MONTGOMERY COUNTY HISTORIC PRESERVATION COMMISSION
STAFF REPORT

Address:	7315 Brookeville Rd., Chevy Chase	Meeting Date:	3/11/2026
Resource:	Individually Listed Master Plan Site Simpson Family House (35/72)	Report Date:	3/4/2026
Applicant:	Paul and Brandy Carlson Matt McDonald, Architect	Public Notice:	2/25/20206
Review:	HAWP	Staff:	Dan Bruechert
Permit Number:	1140619	Tax Credit:	n/a
Proposal:	Partial demolition, construction of new one-story rear addition and screened porch

STAFF RECOMMENDATION

Figure 3: Approved 2021 rear elevation (left) and proposed revision (right).

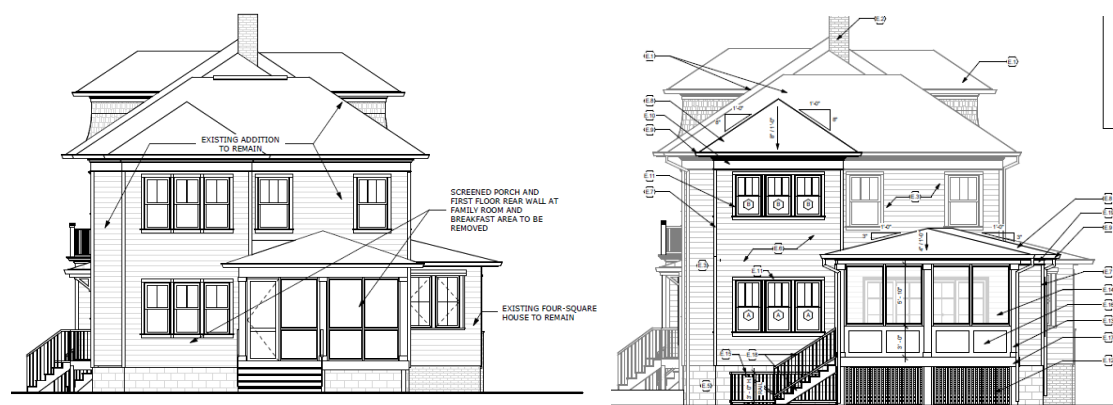
Staff finds the materials are appropriate, as they are consistent with what the HPC previously approved for new construction at the subject property several years ago.

Figure 8: Bird's eye axonometric view from the northwest.

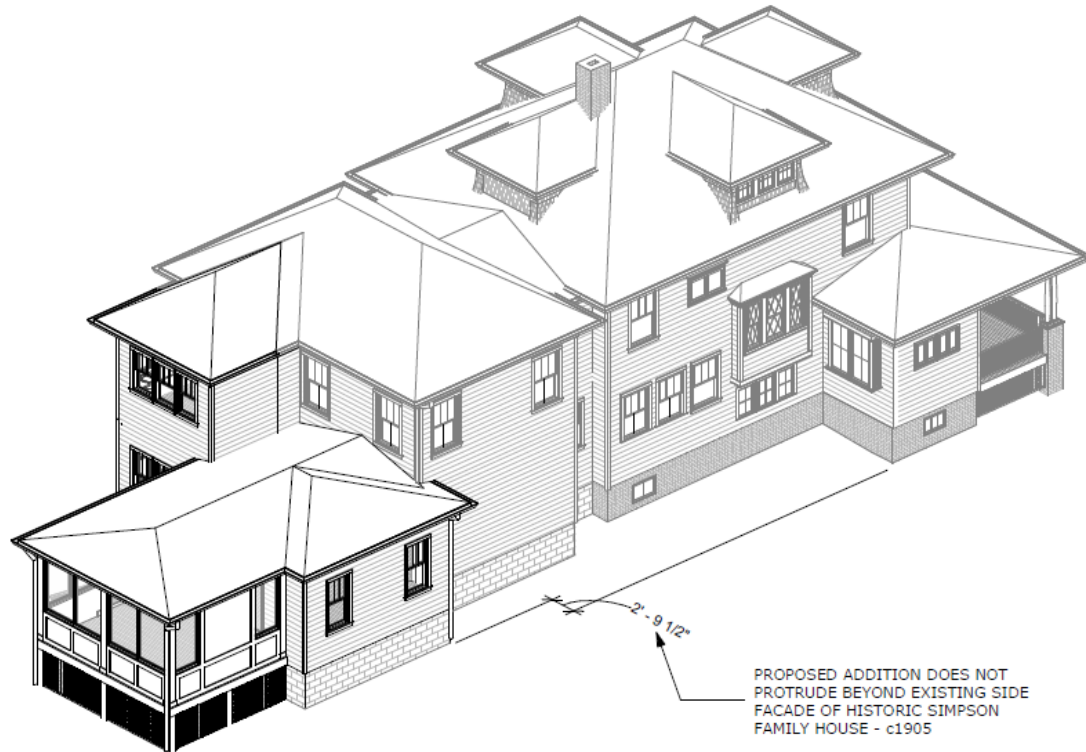
A previously stated in the Preliminary Consultation Staff Report, while Staff finds the overall impact of the proposed additions is appropriate under the requisite guidance. Staff finds that no additional construction could be accommodated at the subject property, beyond what is currently proposed, without detracting from the historic character of the site.

1 Proposed First Floor Plan
 1/4" = 1'-0"

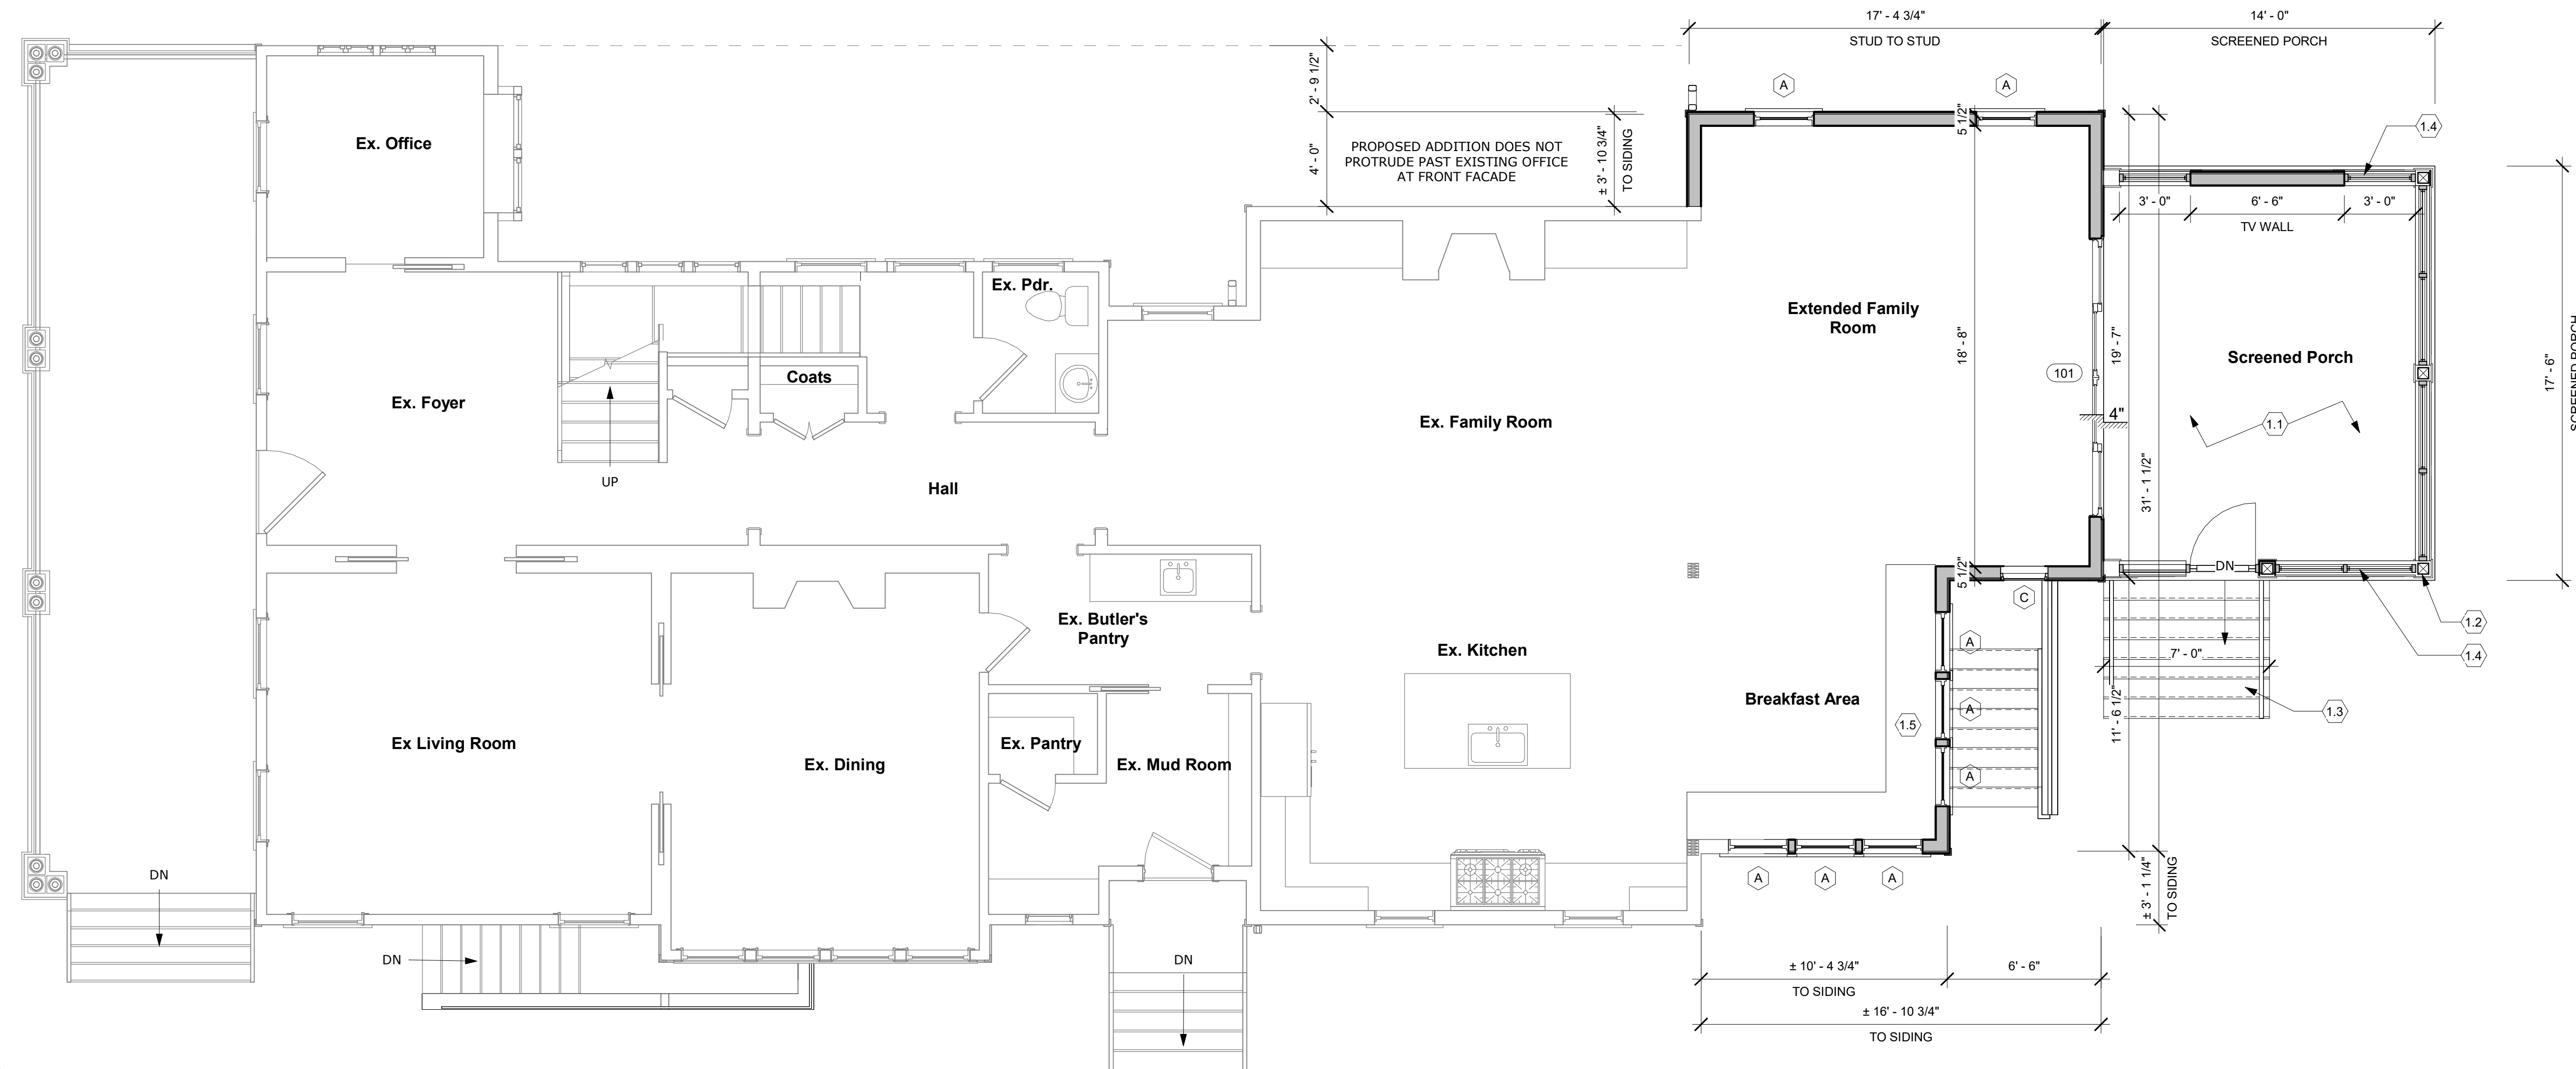
1. The screened in porch decking and stairs must be constructed out of wood. Revised plans need to be submitted to Staff for review before the issuance of the final HAWP approval documents.

The final portion under consideration is the proposed screened in porch (#3 in the floorplan shown in *Figure 4*). This will be constructed to the rear of the norther portion of the addition. The siding treatment of the porch has been changed so there is a solid wainscoting panel below, with framed screens in the upper portion. There is a solid framed panel in the middle of the north (left) elevation. The porch will be covered in a hipped roof, with wrapped columns and beams, and a new set of side-loading stairs. Both the porch decking and the stair treads are identified as "composite" in the submitted plans. The screened in porch measures 14' × 17' 6" (fourteen feet deep by seventeen feet, six inches wide) which is nearly identical to the size of the existing screened in porch. Staff finds the proposed screened-in porch will largely be obscured by the addition to its west (discussed above).
